**Public Comments and NMED Responses on the
Draft 2015 NMED Strategic Plan for the
Kirtland Air Force Base Fuel Spill
March 23, 2015**

2015 STRATEGIC PLAN

DRAFT 12/19/14 - open for public comment

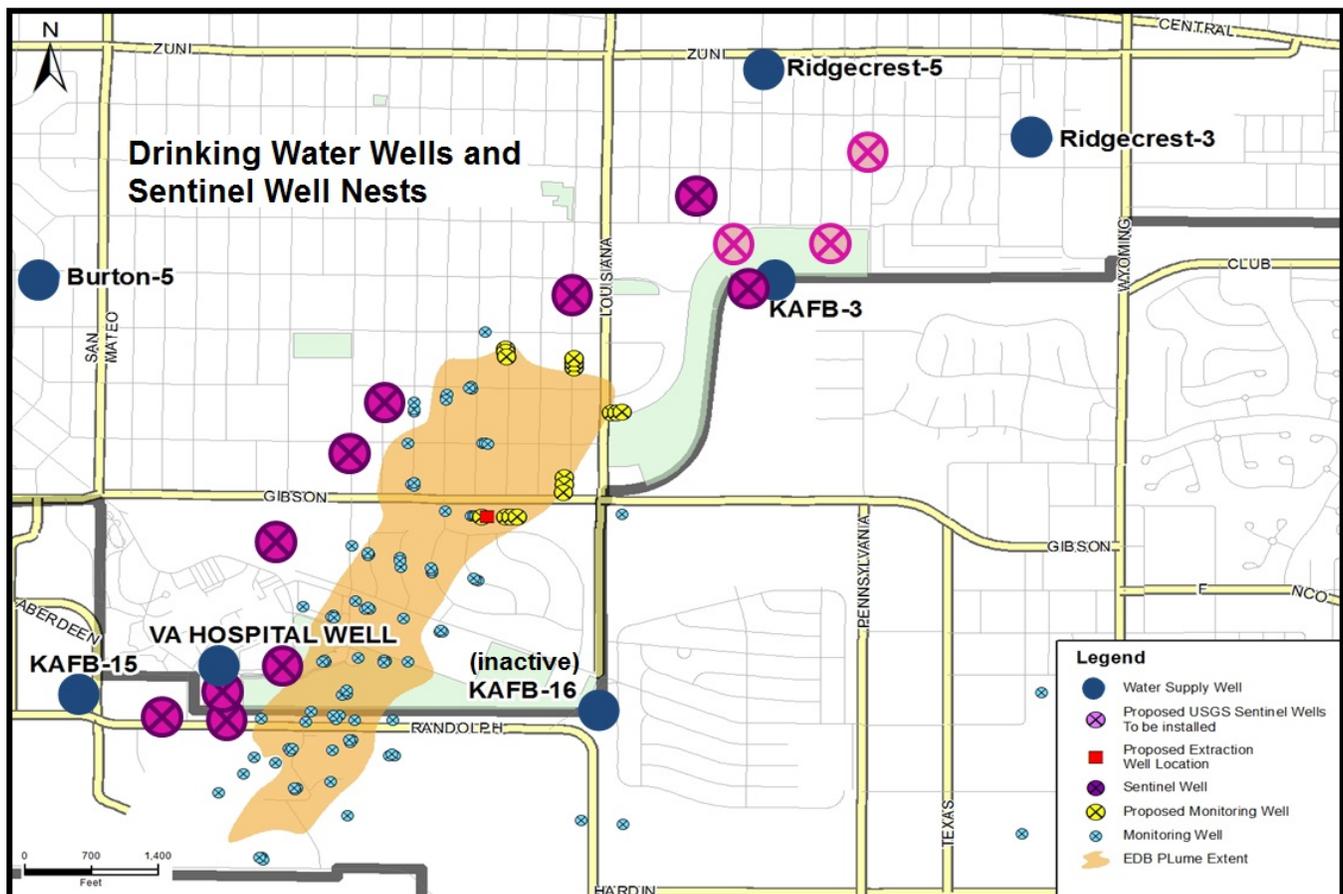
Attached is the PDF with my comments. There should be a pop-up next to each highlighted sentence. In appendix B, I did not read beyond the hydrogeologic working group. For the figure at the end of page 3, what do the lighter-shaded red sentinel wells signify (i.e., those north of KAFB-3)?

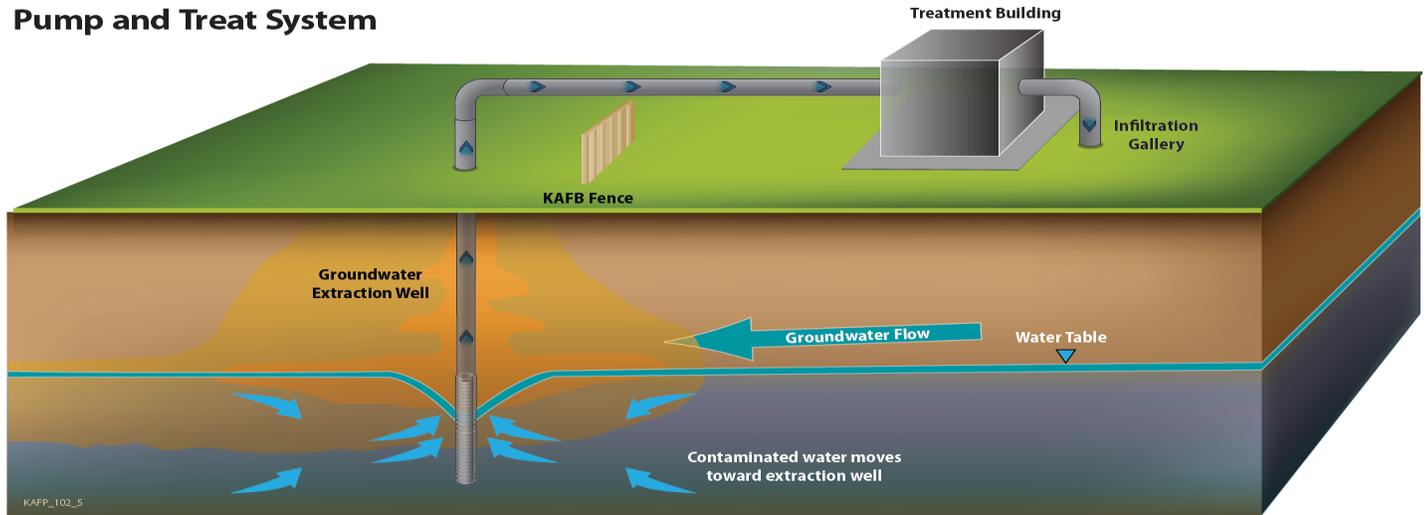
AFCEC	Figure Pump and Treat System	6	<p>This figure doesn’t agree with the figure on page 3 regarding the well location in the downgradient dissolved phase EDB plume.</p>
AFCEC	Pilot Tests	7	<p>Change the following sentence to “NMED will oversee evaluations performed by the Air Force and their contractors to explore the feasibility and effectiveness of variety of interim measures. Remediation technologies under consideration include but are not limited to the following remediation technologies:”</p>

All of your suggested language clarifications are very helpful and have been incorporated into the final Strategic Plan. The figures you commented on were prepared by your contractor, and we are working with you and your contractor to revise these graphics.
